SERVICE

BULLETIN

NUMBER 43

SUBJECT: Stabilizer Link Tube and Rear Support Bearing Bracket

Instructions for Drilling Oil Holes

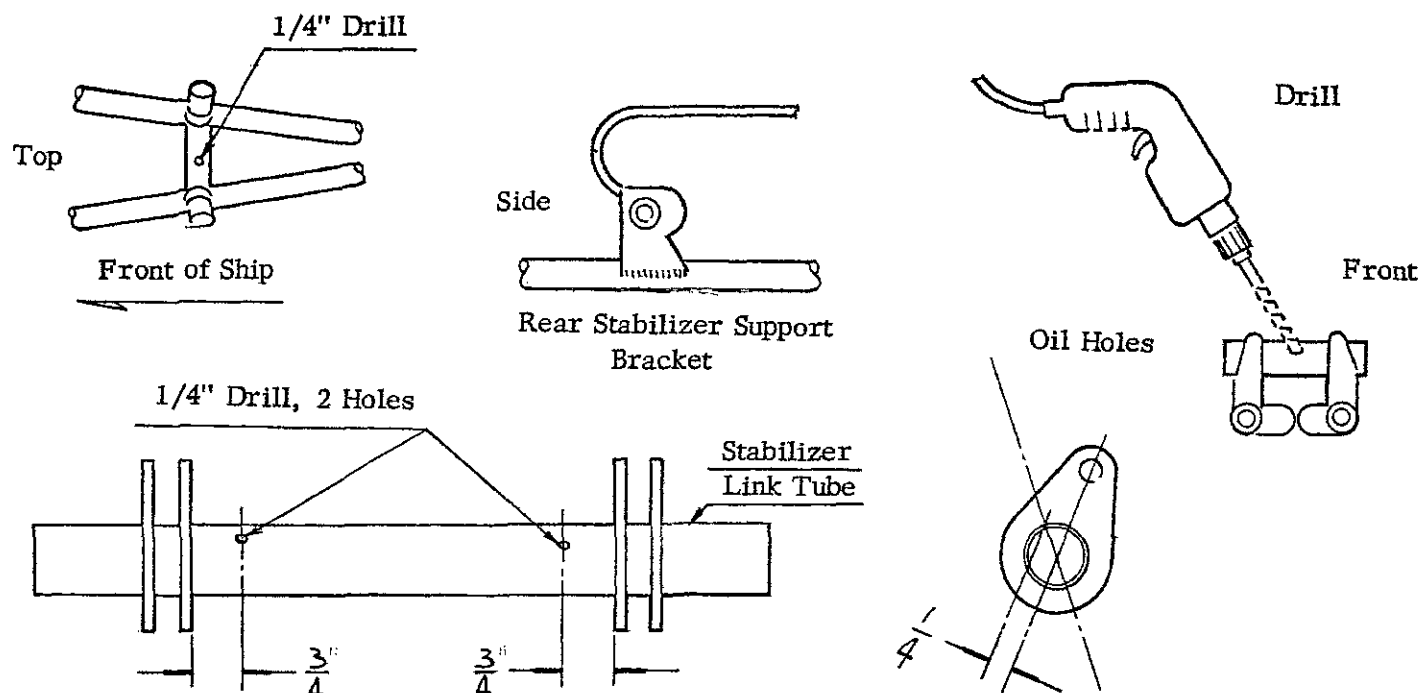
We have received a number of reports of binding in the stabilizer rear support bearing and, as the link tube at the adjustment yoke is of similar construction, there is a possibility that the same difficulty may occur there.

3. Defective parts should be replaced.
4. Before reassembling the parts, a 1/4" oil hole should be drilled in the top center of the stabilizer rear support bearing tube and also 3/4" inboard of each attachment lug on the link tube as shown on the attached sketch unless such holes are already present.

If an extension drill is not available to drill the oil hole in the stabilizer rear support bracket, a 3/16" hole may be drilled at an angle, as shown and slightly to the rear of the top center if necessary.

An extension drill may be made by brazing a 1/4" drill to a length of 1/4" cold roll steel rod.
